**CHICOPEE FALLS
LOCAL PROTECTION PROJECT**

DESIGN MEMORANDUM NO. 5

EMBANKMENTS AND FOUNDATIONS

Design Memorandum No. 5, Embankment and Foundations for Chicopee Falls Project, Massachusetts, is approved subject to the following comments:

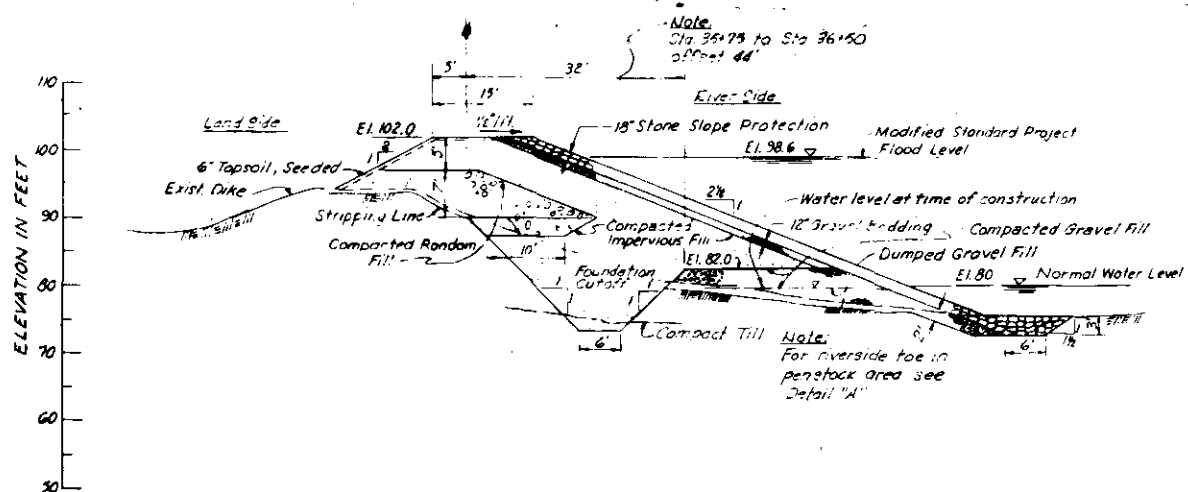
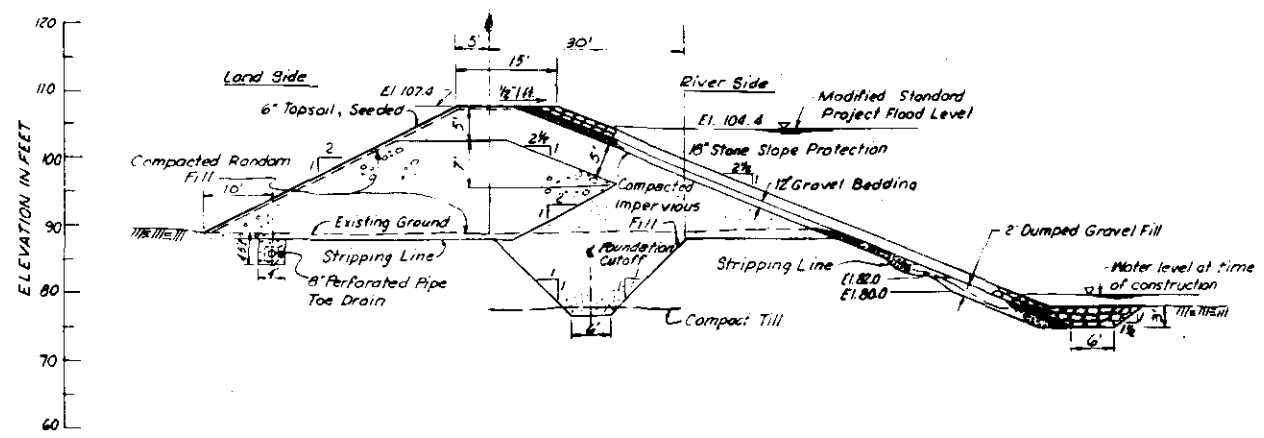
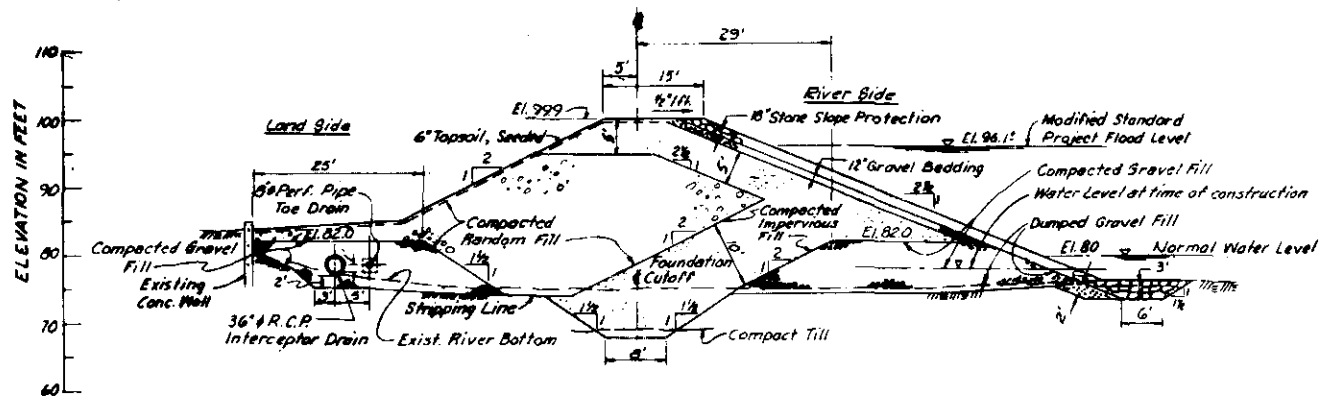
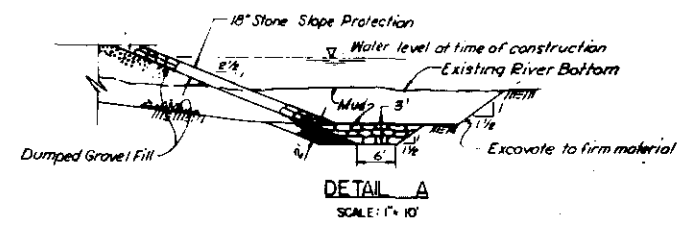
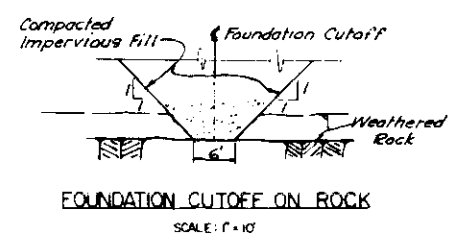
b. Paragraph 13, Plates 17 and 17A. Consideration should be given to making the bottom width of the cutoff at least 8 feet so that the fill can be compacted with standard compactors.

c. Plate 17 and 17A. Consideration should be given to simplifying the zoning of some of the sections shown on these plates. One suggestion would be a central core section instead of connecting the cutoff as shown with the riverside blanket since the cutoff cannot be made at the toe.

2. Comment as to the adequacy of the 6-foot bottom width of the foundation cut-off was inadvertently omitted in paragraph 13. It is planned to place the first layer of impervious fill with a thickness of 18 inches and compact it with 12 passes of the specified roller. In view of the relatively low heads and characteristics of the impervious fill, it is considered that this procedure will provide an adequate cut-off. Such construction eliminates the necessity for completely dewatering the bottom of the excavation prior to placement of the first lift and the need for using hand tampers or rollers to obtain compaction on smaller lifts.

3. Regarding the dike sections on Plates 17 and 17A, much thought was given to the zoning of these sections for ease of construction. The dikes as designed provide a cofferdam between the cut-off excavation and the river, which will aid in the dewatering and prevent erosion during construction. The dikes were designed to provide only two zones, each with sufficient width for satisfactory operation of spreading and compaction equipment. Such a design also does not require concurrent construction of the two fill zones.
